SERVICE INFORMATION LETTER

SERVICE INFORMATION LETTER NO. 0154

1. SUBJECT: Starter Circuit Wiring Modification
2. MODEL: F-28F, 280F, and 280FX
3. EFFECTIVITY: All serial numbers
4. BACKGROUND:

Figure 1.

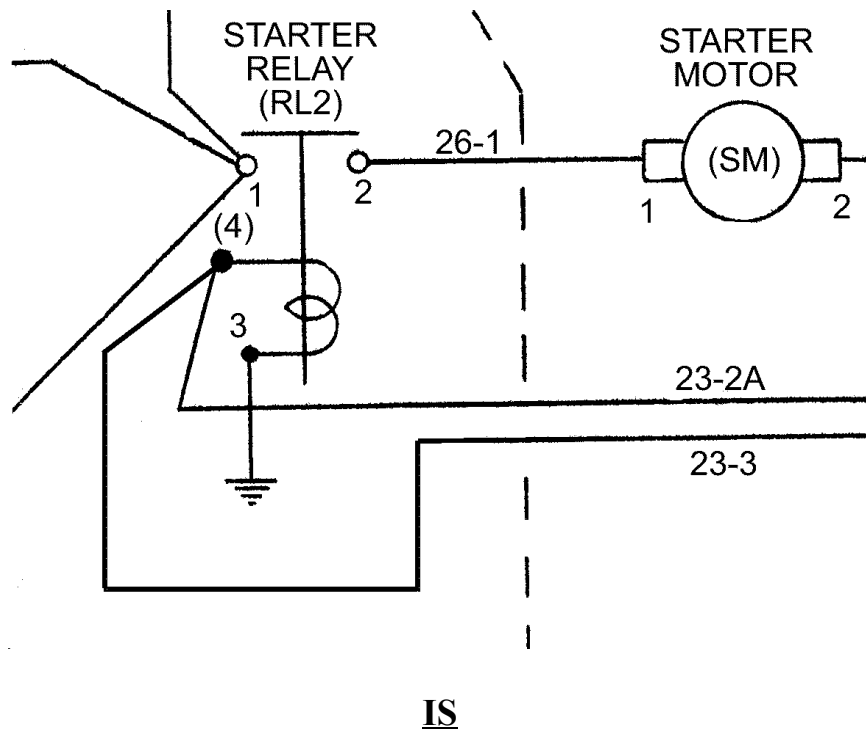
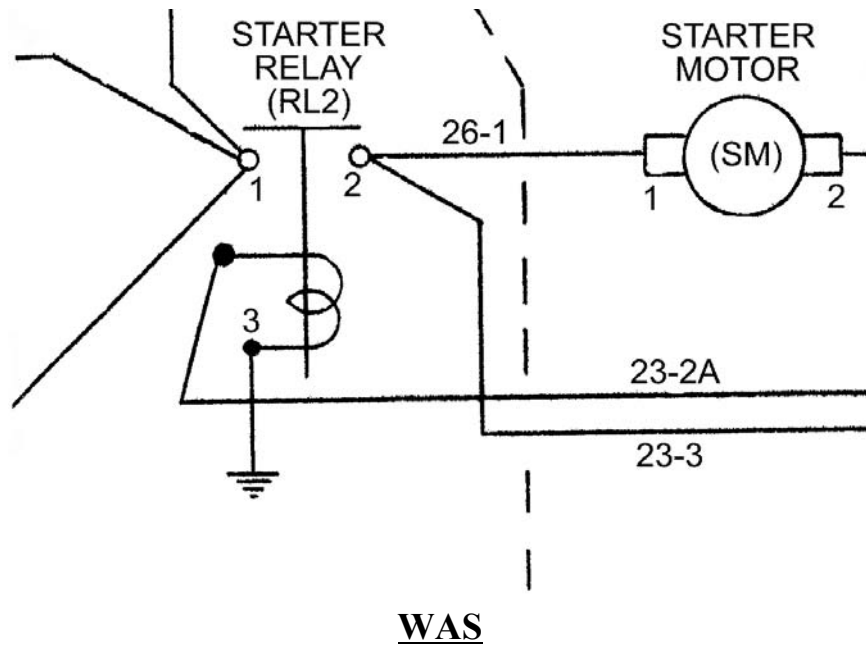
- a. Remove wire 23-3 from terminal 2 of the start relay (RL2). Remove the terminal from the end of the wire and install a new terminal (P/N BB-837-10 or equivalent). Install wire 23-3 on the start relay coil terminal (terminal 4) along with wire 23-2A (Refer to Figure 1).
- b. Aircraft equipped with a 24 volt electrical system: Remove the starter switch from the pilot’s collective stick. Disconnect the pushbutton switch from the wiring and install a new switch (P/N 30-1UL). Install the starter switch into the pilot’s collective stick.
- c. Aircraft equipped with a 24 volt electrical system: Determine the rating of the “START” or “IGNITION” switch/circuit breaker in the switch panel. If the
